IN THE DRAWINGS:

DOCKET NO.: 826.1662

FIG. 1

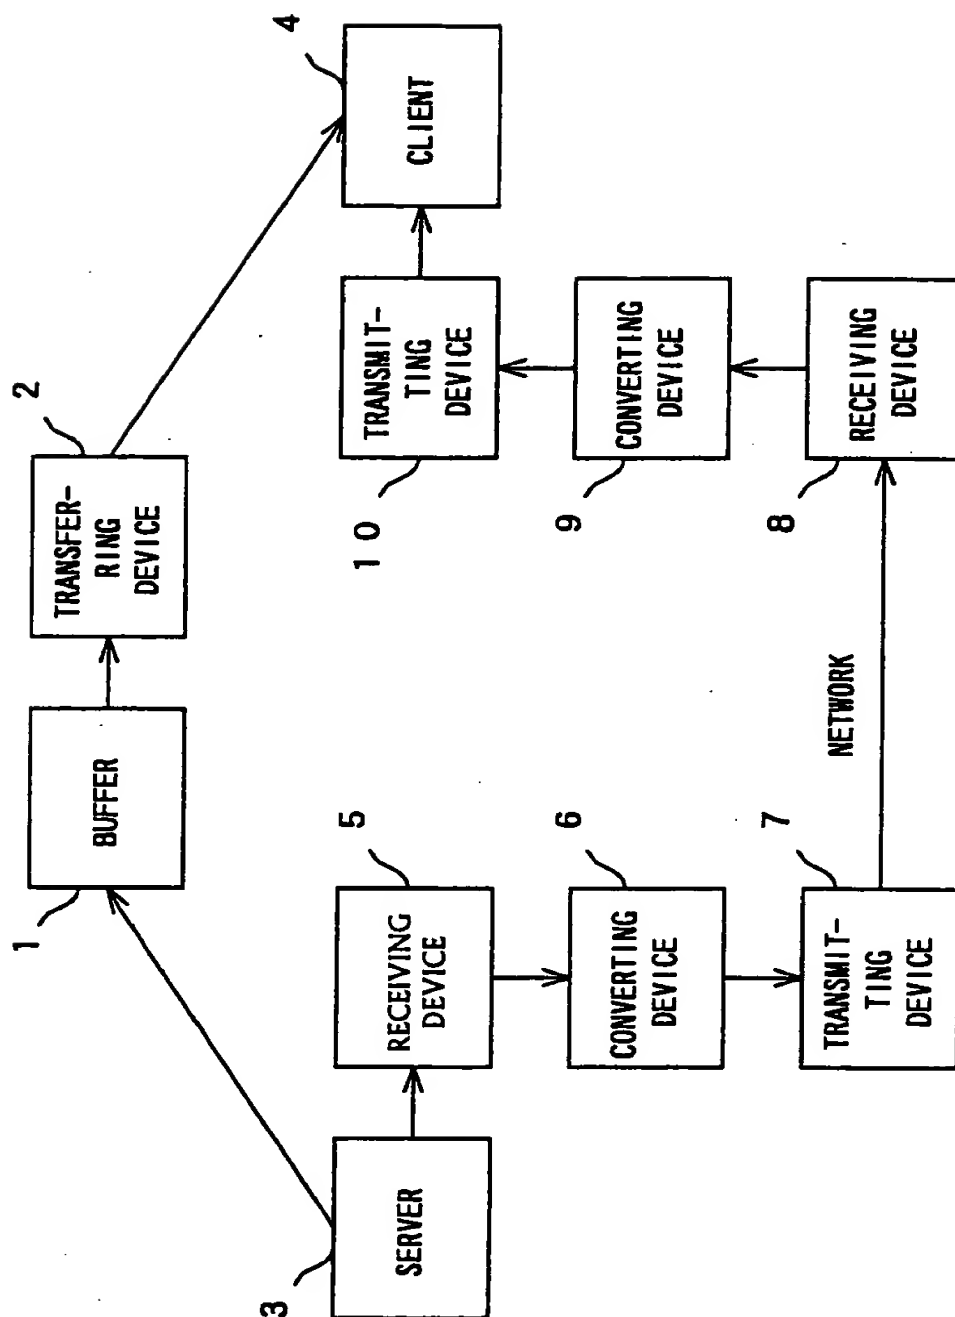
In the Office Action at items 1-6, the Examiner objected to the drawings. In order to overcome these objections, replacement figures are submitted herewith. In FIG. 1 the term --deceiving device is replaced with the term "receiving device." In FIGs. 7 and 14, the box labeled --AGENT REPEATING DEVICE-- is replaced with the label --AGENT RELAYING DEVICE--.
